## OUTCOMES COMMITTEE

**SUBJECT:** Post Exhibition - Villawood Town Centre Development Control Plan 2020 - Amendment No.3  
**Premises:** 1 Villawood Road Villawood (Lot:1 DP:1013056)  
**Applicant:** DMPS (Daniel McNamara Planning Solutions)  
**Owner:** ABA Holdings NSW Pty Ltd (Director/Secretary - Khaled Diab)  
**Zoning:** E1 – Local Centre

Draft Amendment No.3

Figure 5. Vehicular Access and Car Parking in Villawood Town Centre

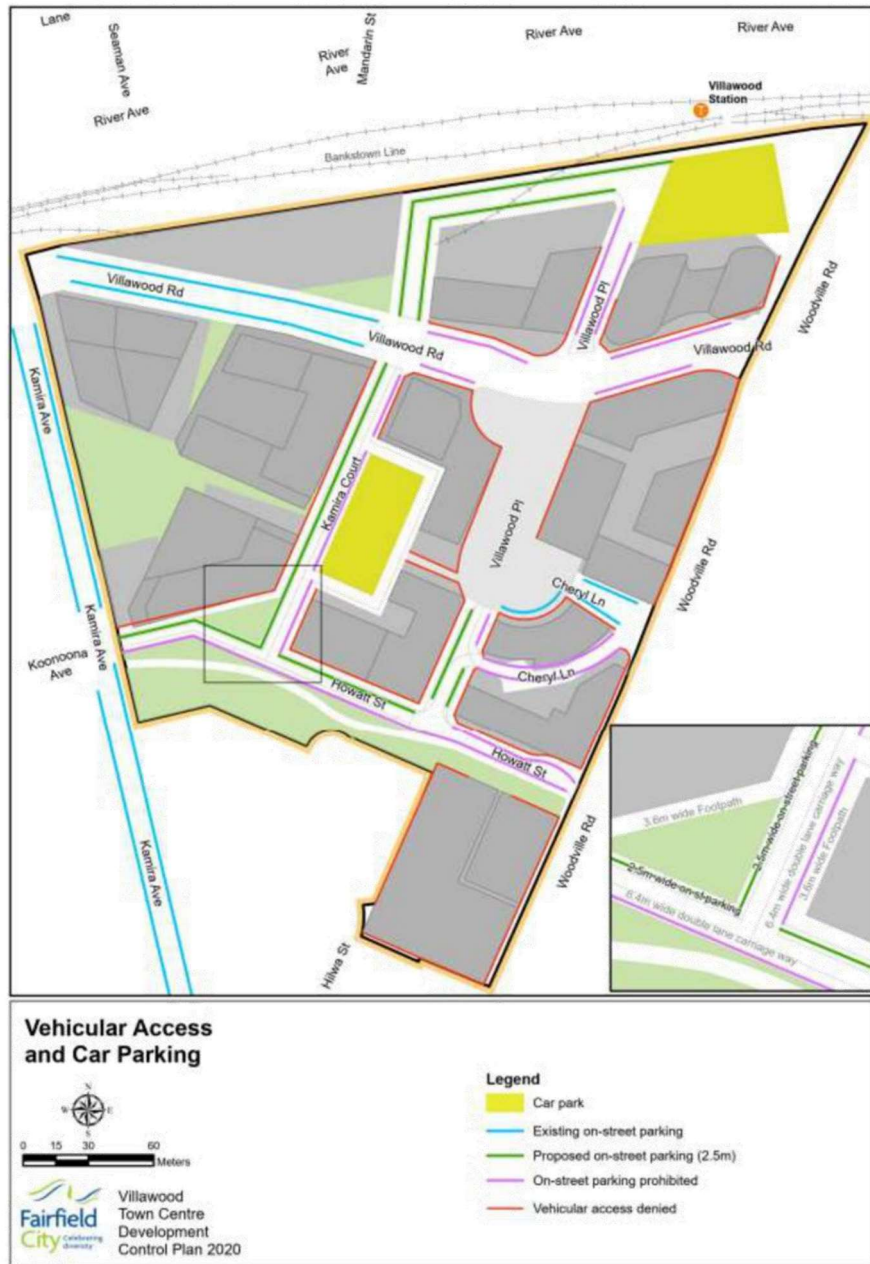
- Villawood Town Centre – Setbacks and number to storeys (Figure 4);
- Vehicular access and car parking in Villawood Town Centre (Figure 5); and
- Active street frontage and pedestrian connectivity in Villawood Town Centre (Figure 6).

10. Vehicular access must be consistent with Figure 5 below. Any significant redevelopment of 896-898 Woodville Road and 15 Hilwa Street (including construction of a basement level) must make provision for shared access to 896A Woodville Road via a suitable easement that allows for construction of a breakthrough basement connection at the first basement level. Access to 896A Woodville Road will not be permitted from Woodville Road.
